Alachua County Environmental Protection Department

Re: 2025 Santa Fe River Basin Management Action Plan

Florida Department of Environmental Protection
Proposed Basin Management Action Plan
for the Santa Fe River
Review Comments on Behalf of Alachua County
May 9, 2025

Figure 1: Santa Fe River BMAP and PFA Boundaries (source: FDEP 2025 draft BMAP)

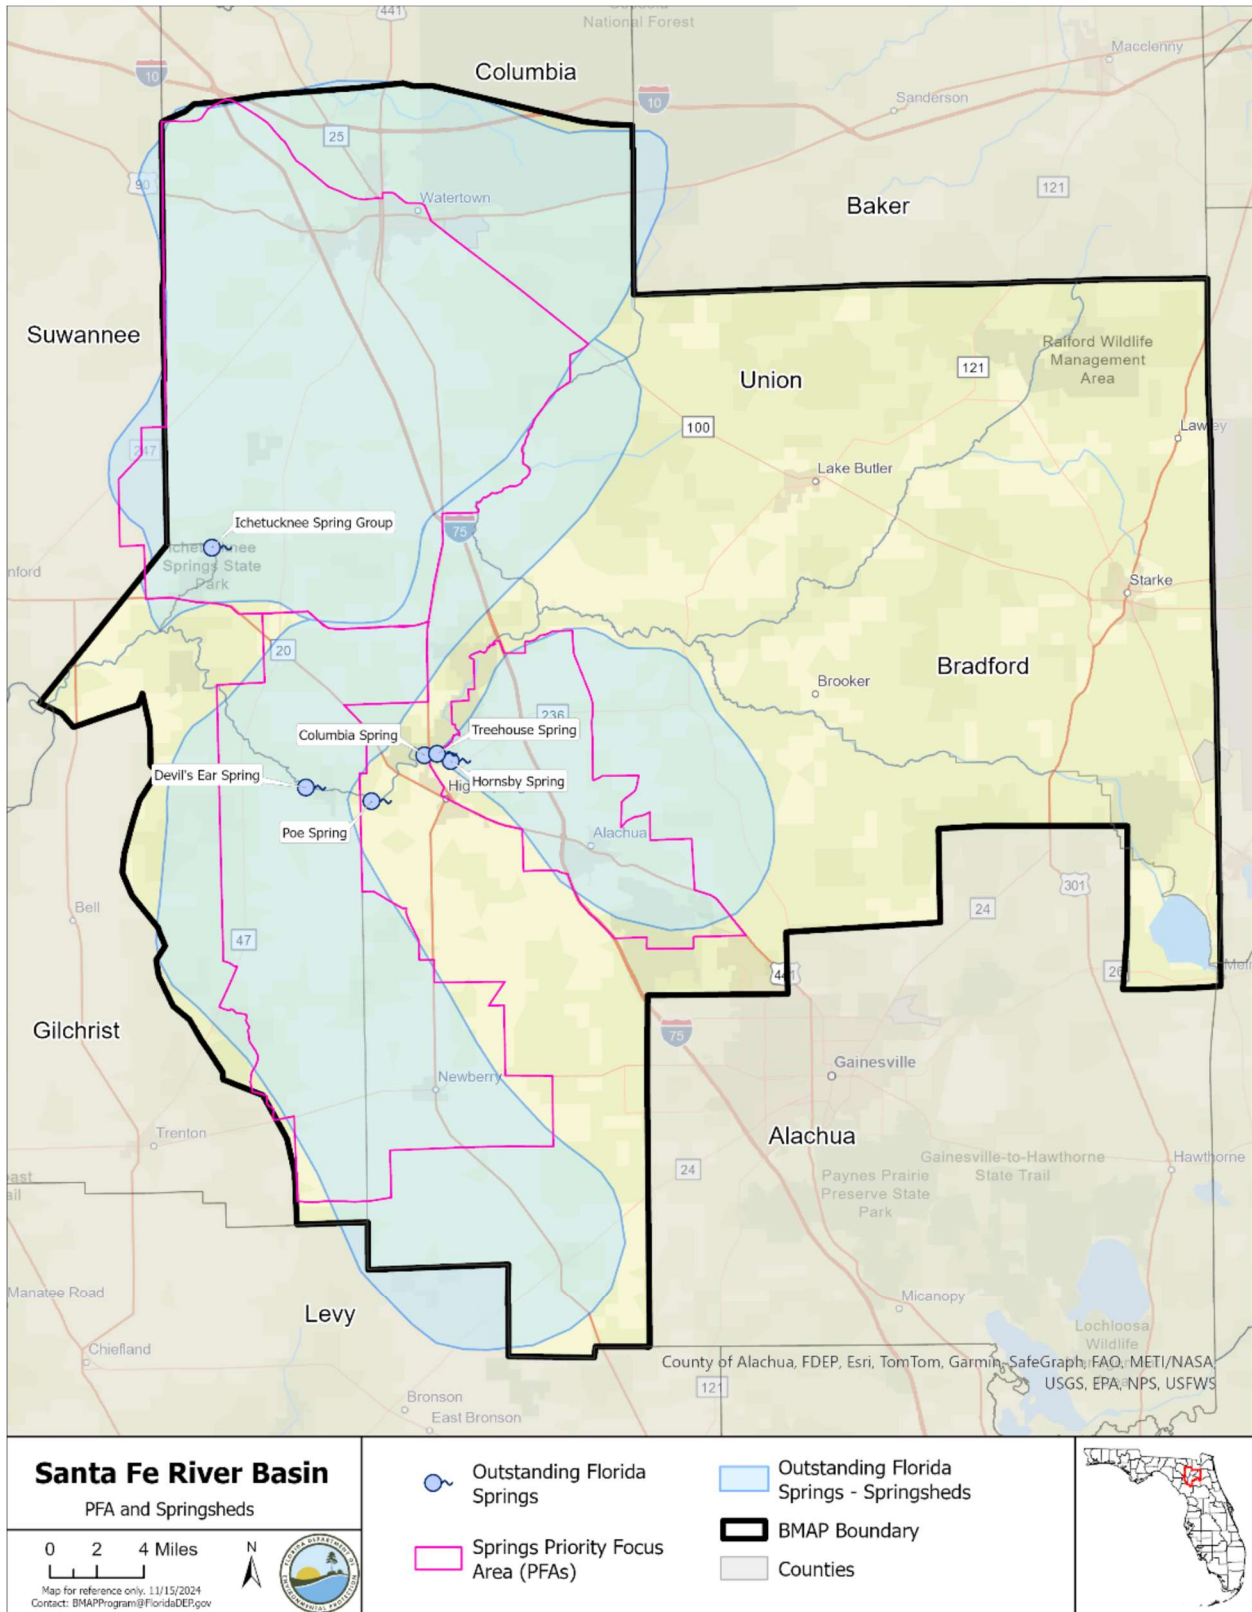
The draft BMAP area includes many springs, some of which have defined springsheds while others do not. Defined springsheds are shown in **Figure 1** below, which was taken from the draft BMAP document. Areas “outside the springsheds” include all yellow shaded areas within the BMAP boundary. The County has overarching concerns about the inclusion of areas located “outside the springsheds” to estimate loads and

In the way FDEPs methodology for estimating loads and associated reductions for areas located “outside the springsheds” is presented, it seems there is an assumption that if a spring does not have a defined springshed, then it must receive flow from ALL AREAS that are outside of the existing defined springshed bounds, but still within the BMAP boundary. An extreme example of this is that septic system loads to the groundwater near Lake Santa Fe are assumed to be contributing to elevated nitrate at the Columbia Spring vent, which is over 30 miles away.

The draft BMAP reports the “outside the springsheds” area as 550,985 acres, which is larger than the sum total of all other springshed areas (535,789 acres; **Table 1**). Accordingly, the County has broad concerns that the contributing area for springs outside the springsheds is being significantly overestimated, resulting in overestimates of NSILT loads to these springs and an unequitable allocation of required reductions to stakeholders. Since FDEP is required to equitably allocate pollutant load reductions per Section 403.067 (F.S.), we therefore suggest that all load estimates and required reductions for areas “outside springshed areas” should be removed from the draft BMAP. Loads should be recalculated and reallocated based upon defined springsheds and delineated loading areas rather than grouping areas “outside of the springshed” together. If a spring vent is not meeting the TMDL target of 0.35 mg/L nitrate and it is not within a defined springshed, then a springshed for that spring vent should be delineated and load reductions should be confined to that defined springshed. Entities should not be allocated nutrient reductions for areas without defined springsheds.

Figure 2: Confined and Unconfined Aquifers in the Santa Fe Basin

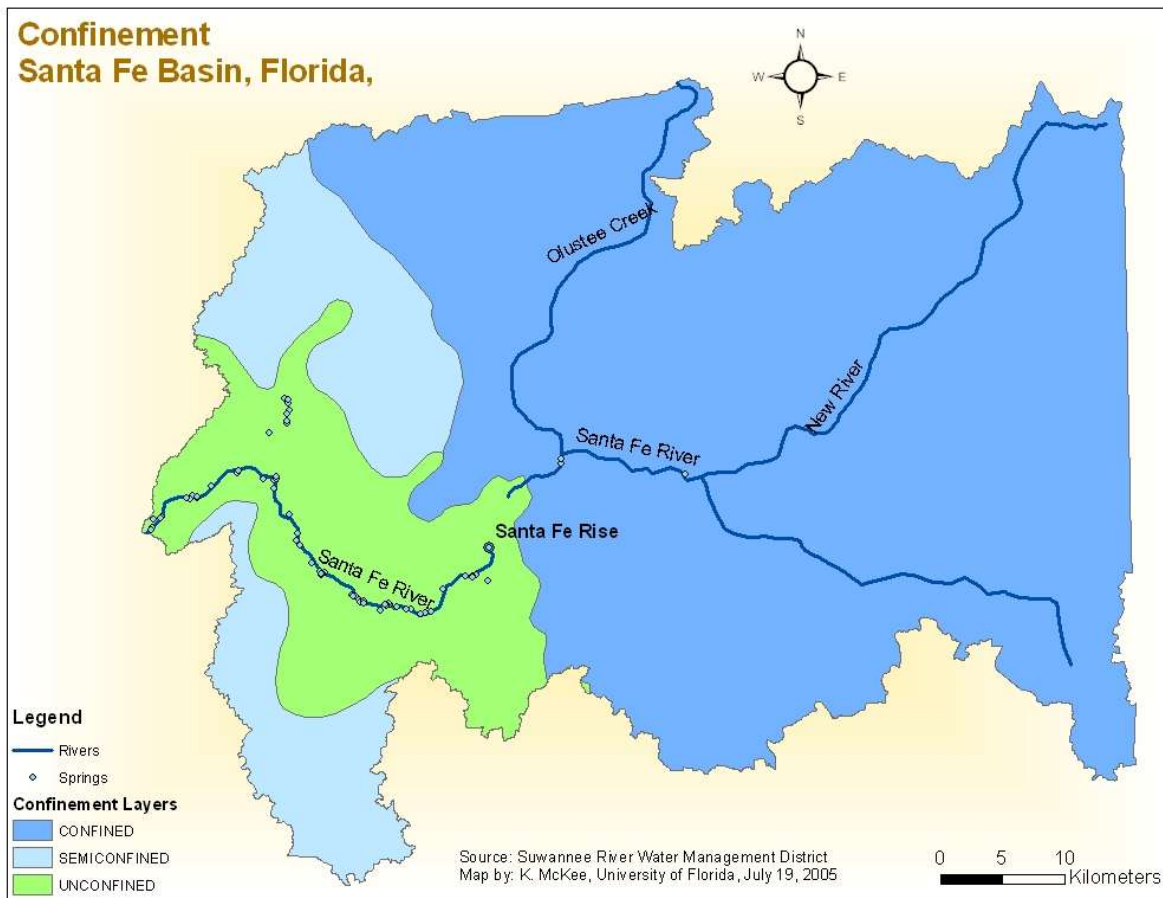
It is important to consider the different geologic formations in the Santa Fe basin as these directly affect aquifer recharge (see **Figure 2**; UF, 2005). The Upper Santa Fe basin sits atop the nearly impervious Hawthorn formation (a geologic formation of clay, quartz sand, carbonate, and phosphate), which is perched well above the Floridan Aquifer. This confining layer limits aquifer recharge and discharge along this stretch of the river. The Upper Santa Fe and the Lower Santa Fe are neatly divided by the Cody Scarp, which runs through O’Leno State Park. Here the Santa Fe River flows underground for three miles before re-emerging at River Rise Preserve State Park. Aquifer confinement in the Lower Santa Fe basin either thins or is completely absent, allowing increased aquifer recharge and discharge. The draft BMAP recognizes these differences in hydrology by stating:

Given these significant differences in hydrology, we suggest that, in the absence of a defined springshed, it is unreasonable to assume that loads to the groundwater in the Upper Santa Fe basin will significantly contribute to elevated nutrient concentrations at spring vents in the Lower Santa Fe basin.

Figure 3: Santa Fe River WBIDs in Alachua County

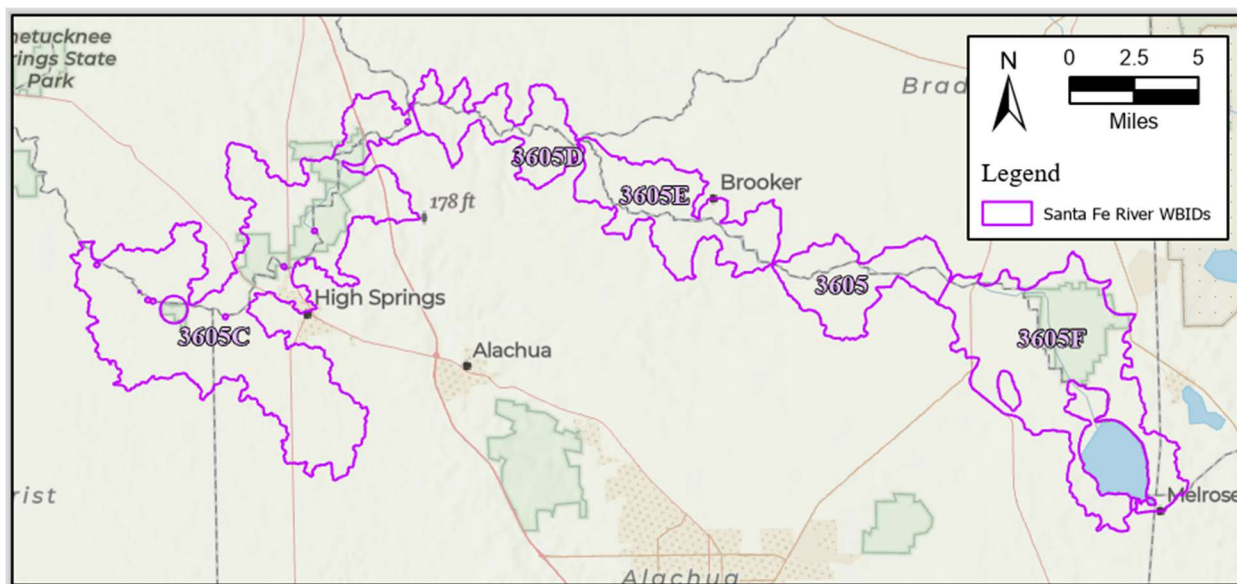
Additionally, if the areas outside the springsheds are considered to be contributing nutrient loads to the rivers, then this should be supported by an assessment of surface water quality data from the various WBIDs along the Santa Fe River showing impaired status. The Santa Fe River in Alachua County comprises 5 FDEP WBID segments: 3605F, 3605, 3605E, 3605D, and 3605C (**Figure 3**). Of these, WBID 3605C is the only section that is not meeting water quality restoration targets of 0.35 mg/L for nitrate (monthly average). None of the upstream WBID are exceeding this target, which indicates that no load reductions are required in the upstream WBID areas to meet the target for the river.

Figure 4: Average Nitrate (2012 to 2022) at Santa Fe River Monitoring Stations

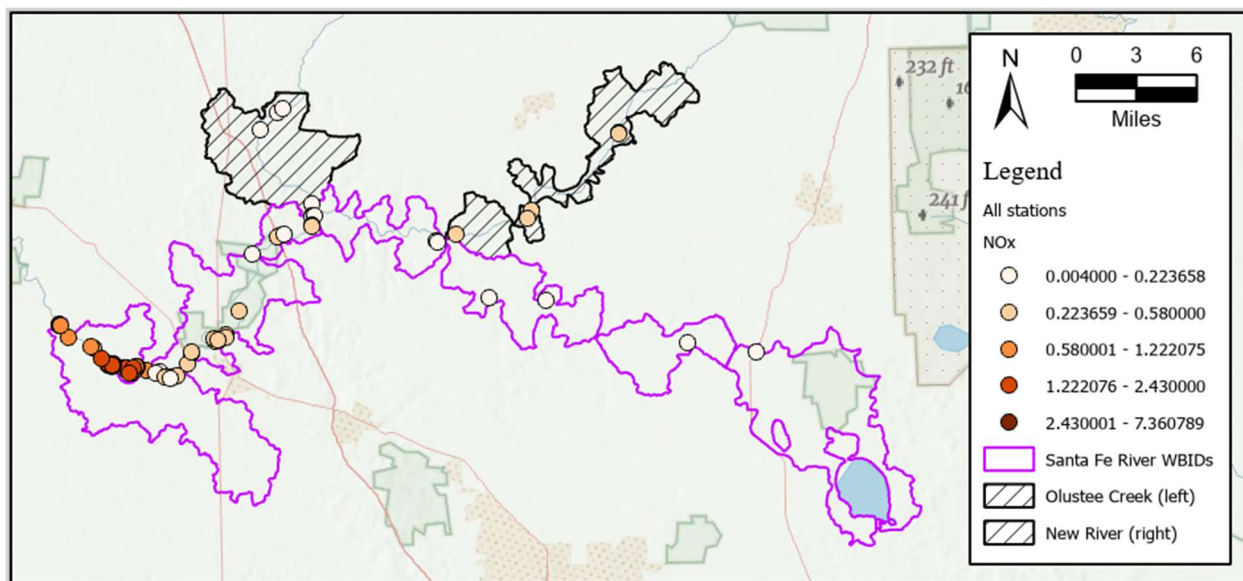
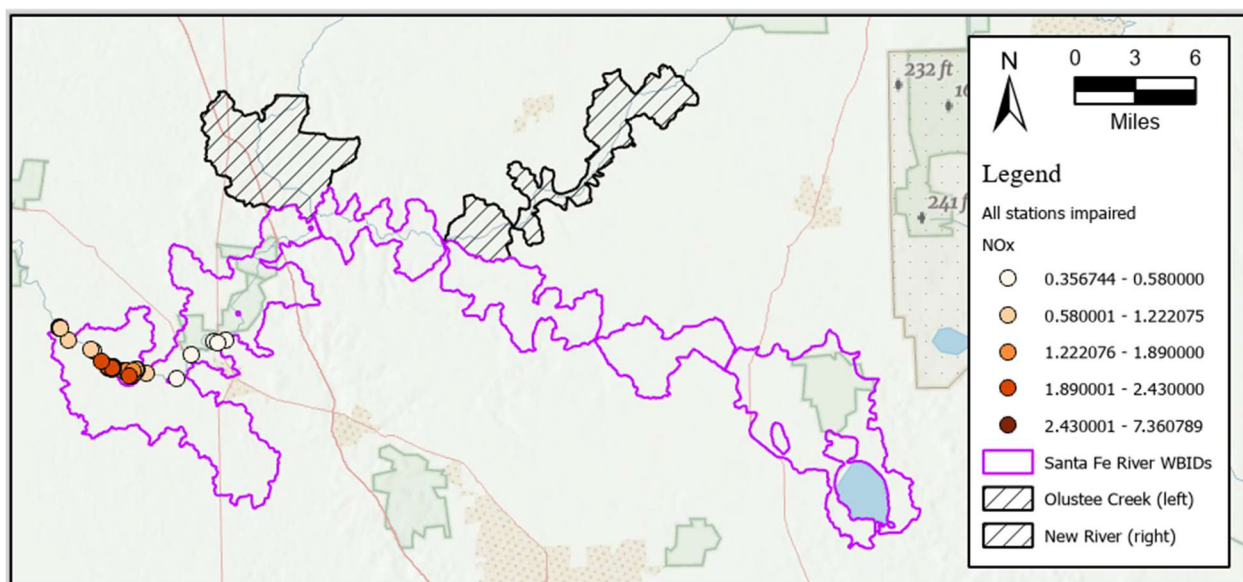
To further support this, we evaluated average nitrate concentrations at individual monitoring stations in the 5 WBID segments outlined above. Nitrate data for all monitoring stations within the 5 WBIDs were downloaded from IWR run 65 for the period from 2012 to 2022. Average nitrate concentrations for all these stations are displayed in **Figure 4**. Sites whose average nitrate concentrations exceed 0.35 mg/L are shown in **Figure 5**. The degree of exceedance is denoted by the color scale. Note that there are no monitoring stations upstream of WBID 3605C that exceed average concentrations of 0.35 mg/L. It is also noteworthy that all stations exceeding average concentrations of 0.35 mg/L are downstream of spring vents. This data indicates that the springs are the primary source of nitrate exceedances in WBID 3605C. To improve water quality at the springs, nitrogen loading should be reduced in their specific springsheds (which are the loading areas). Although some stations in the upstream WBIDs may be close to 0.35 mg/L, it is clear that the most significant sources of nitrate are found at the downstream stations.

This assessment further supports our reasoning that river load reductions are not required for areas outside the springsheds but within the BMAP boundary. If FDEP asserts that nutrient load reductions are required in these upstream areas, then they should provide supporting data which shows that these upstream WBIDs are not meeting the TMDL target. No such data has been provided in the draft BMAP. Therefore, the assumption that “areas outside the springsheds but within the BMAP boundary are considered contributing to the rivers” is unsupported and all associated load reduction calculations operating under this assumption should be removed from the BMAP until adequate supporting documentation is provided.

Figure 6: Correlation Plot for Columbia and Treehouse Springs

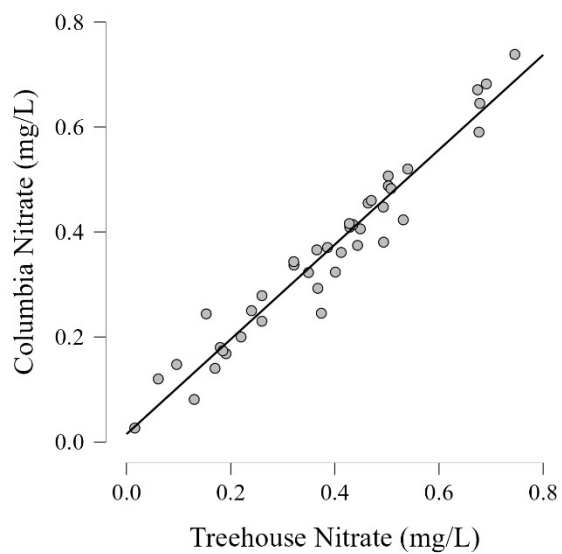
The results of the correlation test show a very strong 1:1 correlation between the two springs, which supports the hypothesis that both springs share the same springshed (**Table 3; Figure 6**). Based on these results, we suggest that it would be appropriate to assign the Treehouse/Hornsby springshed to the Columbia spring. The grouping of the Columbia Spring with the Treehouse/Hornsby springshed is further supported by previous springshed delineations conducted by Upchurch (2008; **Figure 7**).

Figure 8: FDEP Poe OFS Springshed

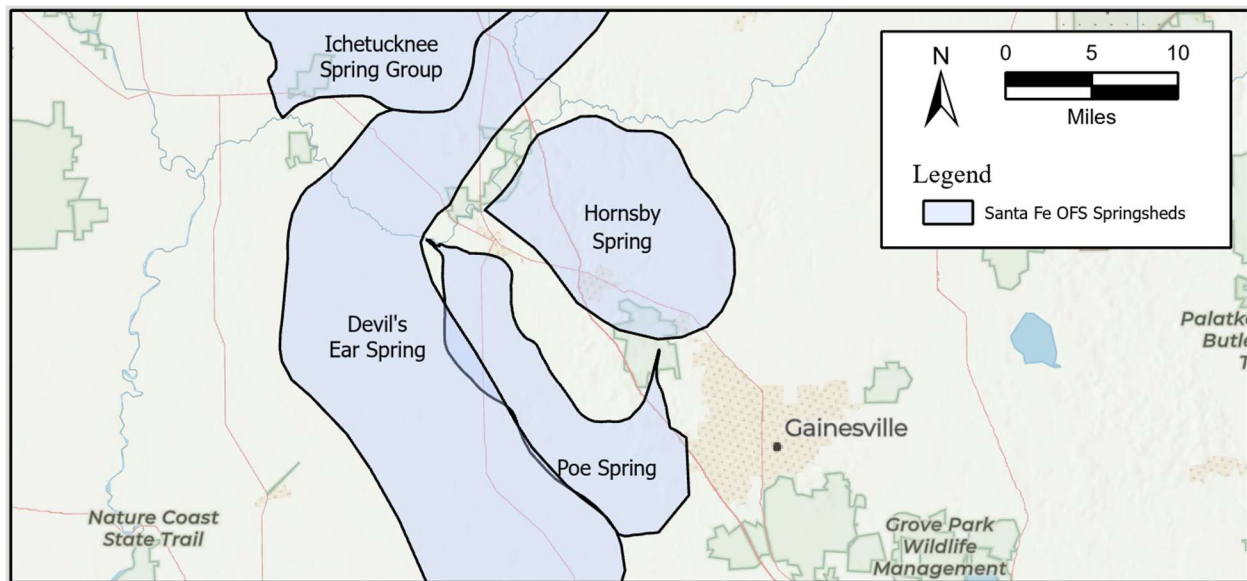
The County notes that data from Poe Springs is used to calculate required load reductions for areas outside the springsheds. There are two issues with this approach. First, Poe Springs has a delineated springshed. The Poe springshed was previously delineated by FDEP (see **Figure 8**). Any NSILT loads outside of this springshed should not be considered as contributing to loads at Poe Springs. Conversely, any loads within this springshed should not be considered as contributing to spring vent loads outside of the springshed. Second, the County notes that Poe Spring is not impaired for nitrate and therefore it does not require load reductions to meet the TMDL. Therefore, the entire Poe springshed area of about 63,000 acres should be excluded from the NSILT calculated loads to GW and associated needed load reductions. It is important to note that although load reductions may not be required in the Poe Springshed, it should still be recognized that projects completed within this springshed to reduce loads to the Santa Fe River should still receive nutrient reduction credit toward the existing TMDL as they reduce loads to the river. The County is committed to protecting Poe Springs and recently conducted an analysis of nutrient sources and is pursuing projects to reduce loading to this basin, regardless of allocations.

Figure 9: Spring Locations (source: Florida Springs Institute)

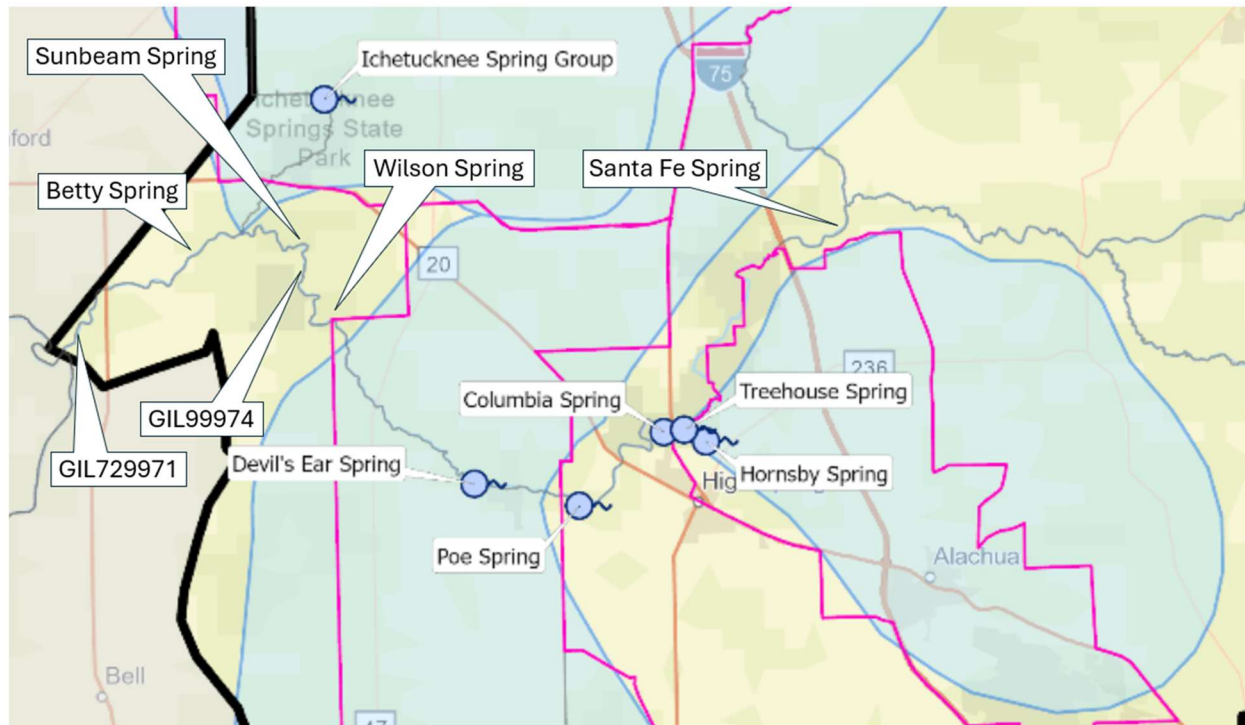
Wilson Spring is the most downstream of the group. It is located ~14 miles away from the most upstream Santa Fe Spring and is completely separated geographically by the Devil’s Ear Springshed. See **Figure 9** below showing the location of Wilson Spring and Santa Fe Spring. It is not reasonable to group these springs together to calculate loads and required reductions for the entire area “outside the springsheds.” The Wilson springshed should be defined, and percent reduction goals should be confined to its springshed area. Note that the previous study by Upchurch (2008) provides a delineation of the Wilson Springshed and it does not overlap Alachua County at all (**Figure 7**). Accordingly, it is inappropriate to ask Alachua County to address loads occurring outside its jurisdictional boundaries.
